REF: S-4-23
DATE: August 10, 2023

| Request | - | Preliminary Drawing of Dorr Street Station |
| Location | - | Northeast corner of Dorr Street & Interstate-475 |

PRELIMINARY DRAWING
SPRINGFIELD TOWNSHIP/CITY OF TOLEDO
TOLEDO-LUCAS COUNTY PLAN COMMISSIONS
REF: S-4-23
DATE: August 10, 2023
TIME: 9:00 A.M.

PRELIMINARY DRAWING

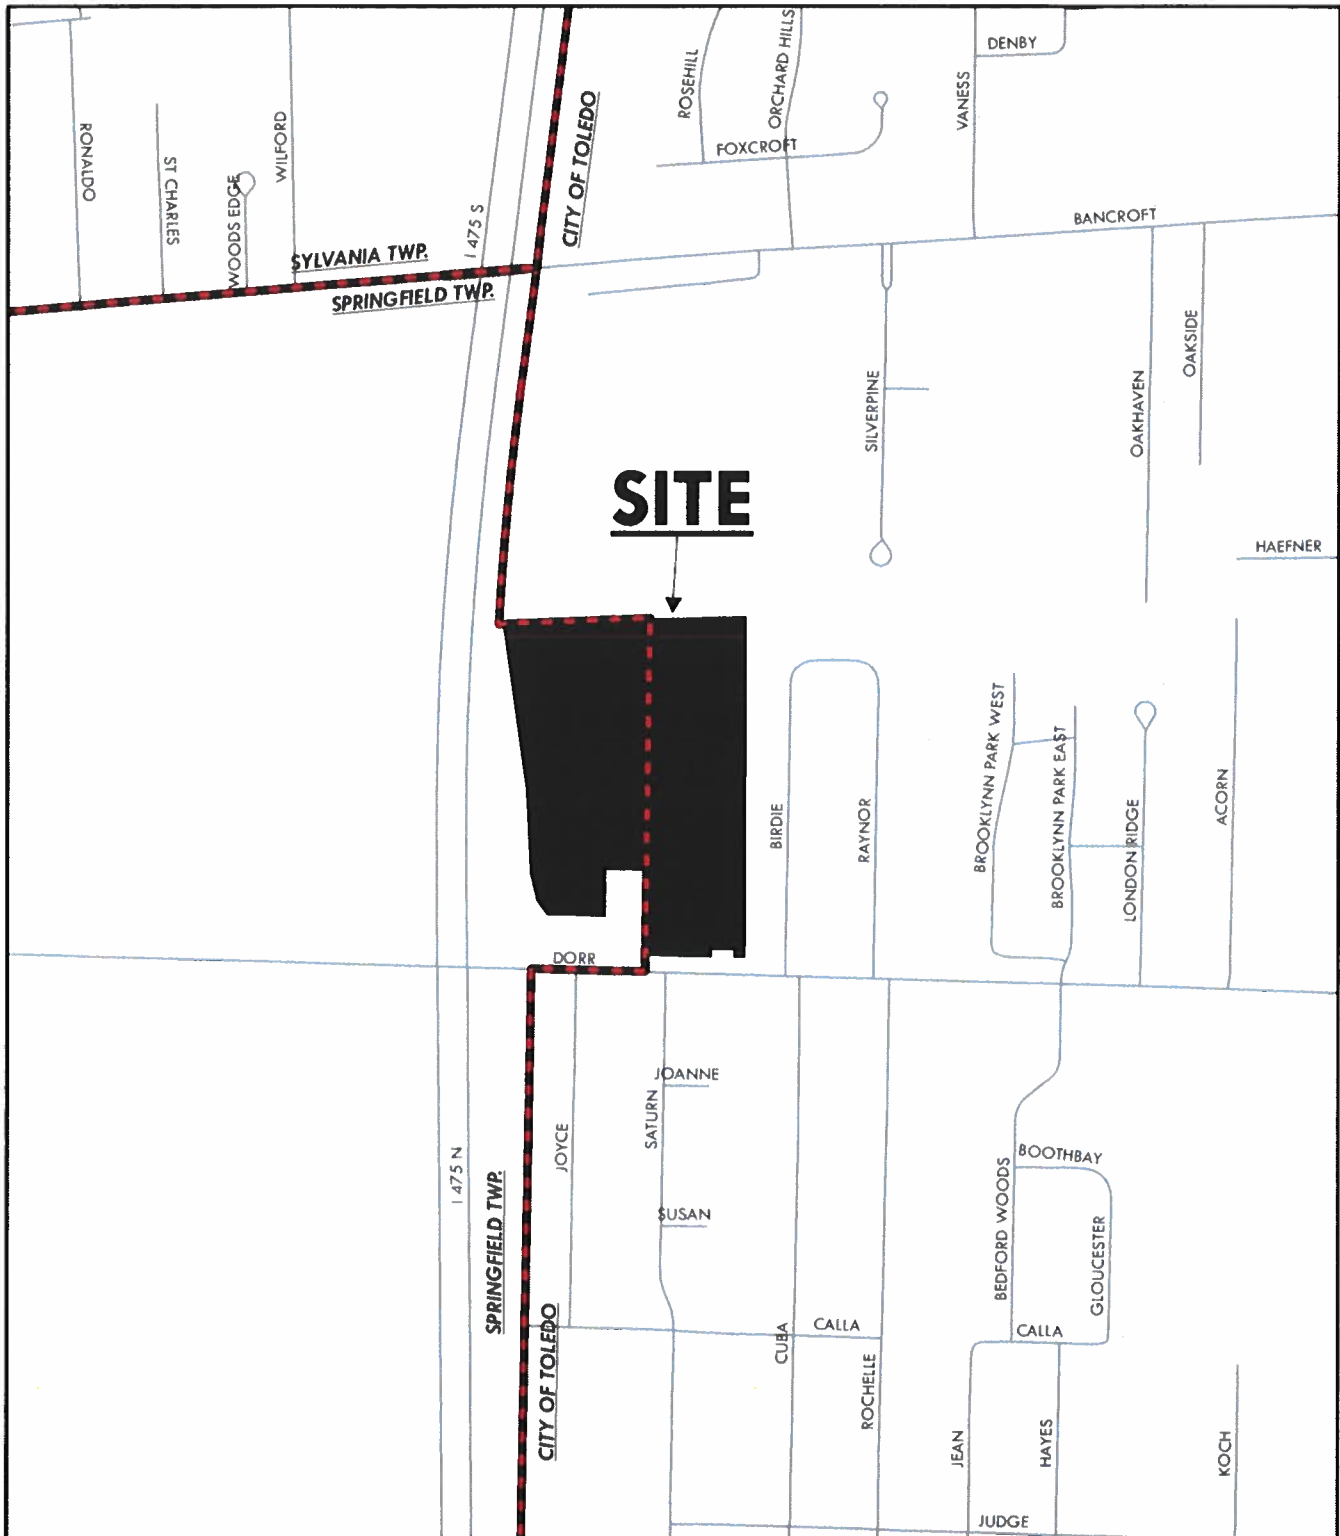
32. The plat shows the proposed waterline located outside of the proposed storm sewers and a few sections of the storm sewer mainline running under the new pavement. This is opposite of the Standard Lucas County design and the storm sewer mainline shall not be located longitudinally under the proposed new roadway. Dedicated easements for drainage shall be provided for sections where the storm sewers are located outside of the right of way.

55. An anti-vehicular access easement shall be placed along the entire frontage of Lots 1, 3, 4, 7 & 8 where abutting Dorr Street & Interstate-475. **Shall be depicted and noted on the Final Plat.**

56. The minimum lot frontage of new subdivision lots in the Dorr Street Interchange Overlay shall be a minimum 150' width, measured along the building setback line. **Not acceptable as depicted on Preliminary Drawing. Lot 7 shall be modified in order to meet the minimum lot frontage of 150' and depicted on the Final Plat.**

59. Per Section 311, any topographic features within and adjacent to the plat for a minimum distance of 200 feet shall be indicated on the Preliminary Drawing. This includes the locations of any floodways, floodplains, wetlands, and any potentially known hazardous areas. **Not acceptable as depicted on Preliminary Drawing. A ditch easement, with dimensions specified, shall be provided for Haefner Ditch and depicted on the Final Plat**
